PETITION FOR A SPECIAL HEARING

In the Matter of
Petition of
Mercantile-Safe Deposit
and Trust Company,
Trustee, Contract Purchaser

To: Mr. Willie H. Adams, Zoning Commissioner
Date: Nov. 12, 1959
From: George E. Goyrell
Subject: Application for Special M-R Hearing.
Ingersoll - Rand Office & Warehouse
Aylesbury Road, 337 W. York Road
8th District.

From: Wolfgang Oehme
To: Willie H. Adams
Date: November 4, 1959
Subject: Proposed Ingersoll-Rand Office & Warehouse
Aylesbury Road 337 W. York Road
District 8

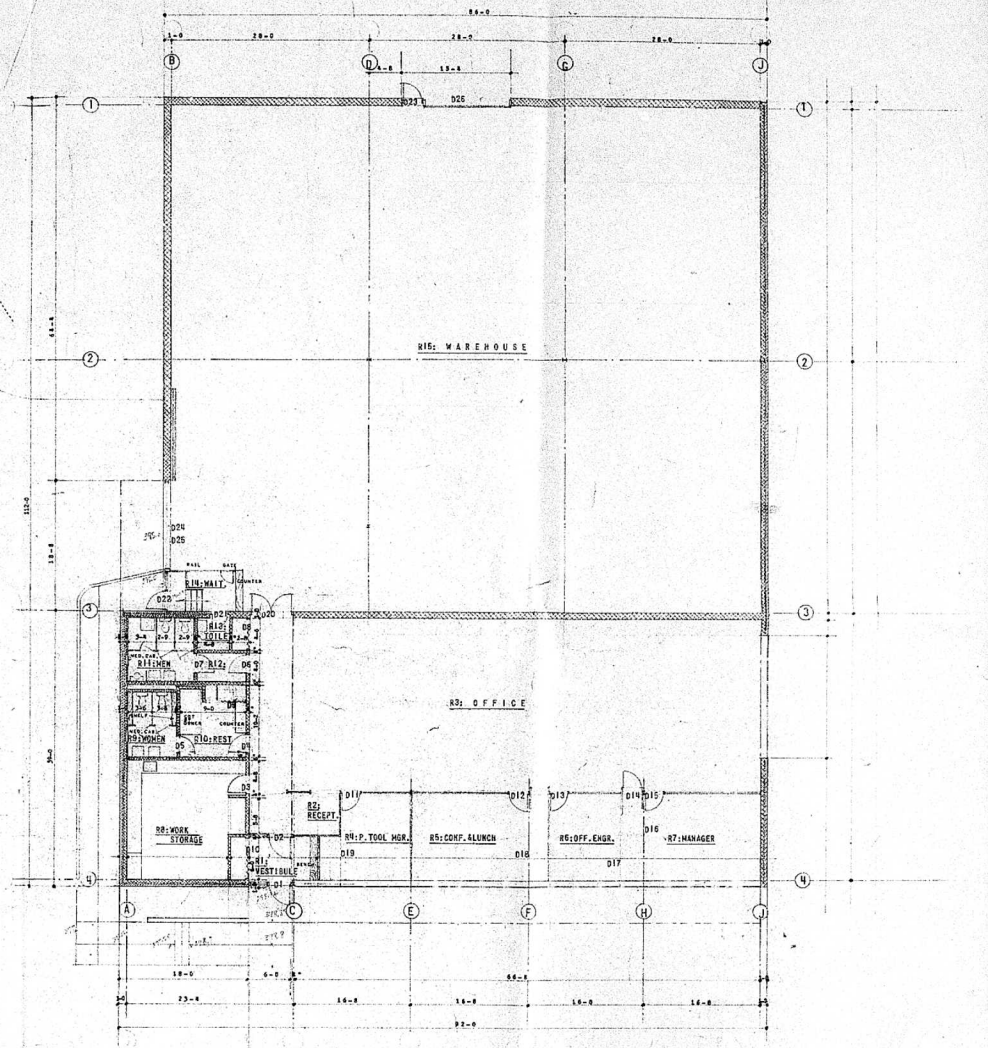
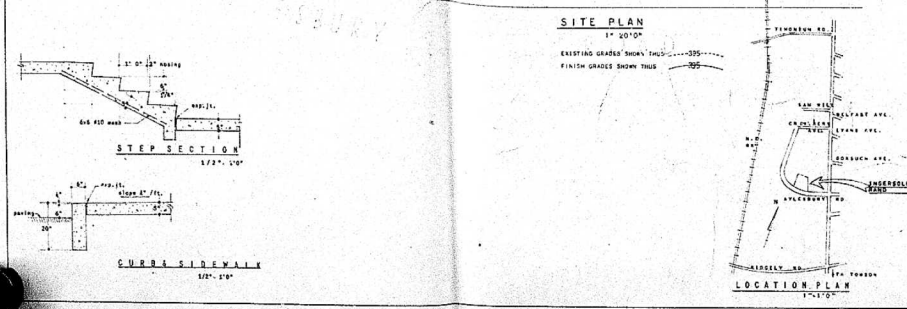
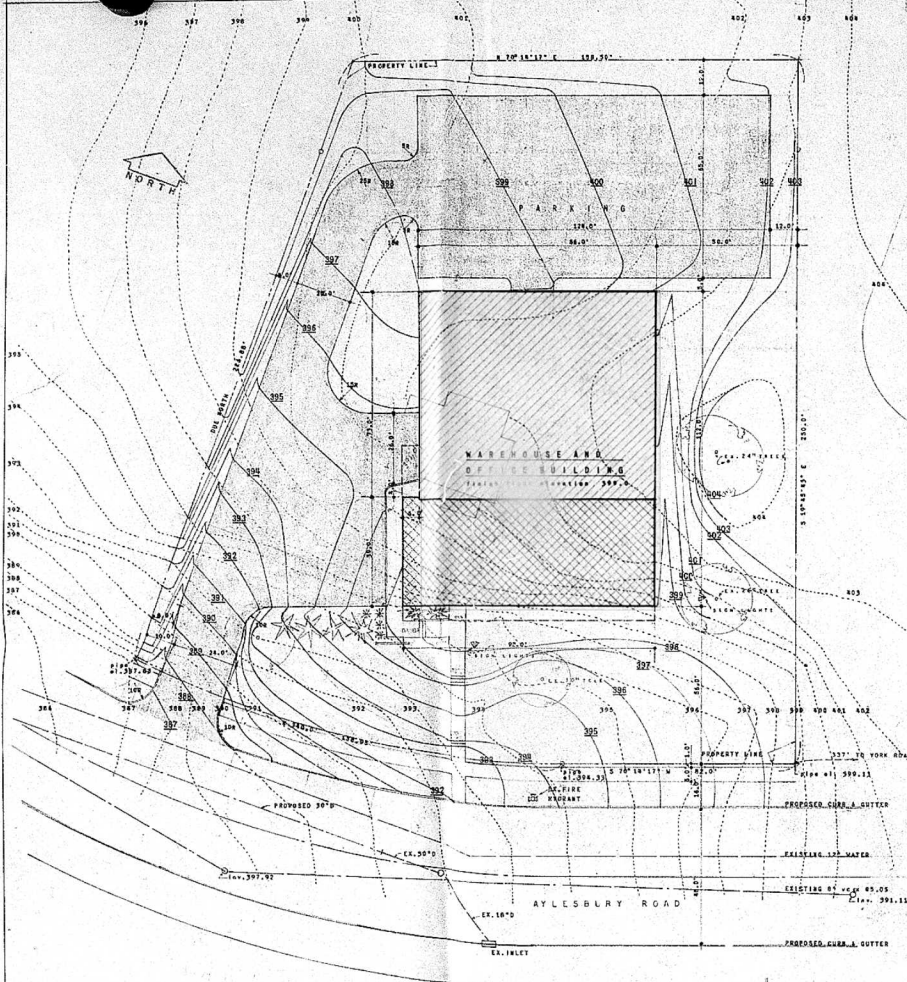
The Office of Planning has reviewed the subject plan and offers
the following comments:

1. A 5' tangent from the property line should be provided before
the radius for the curve is started.
2. Sidewalks should be constructed along Aylesbury Road.
3. It is suggested that the Owners and/or developers should give
some consideration for the preparation of a landscaping plan.
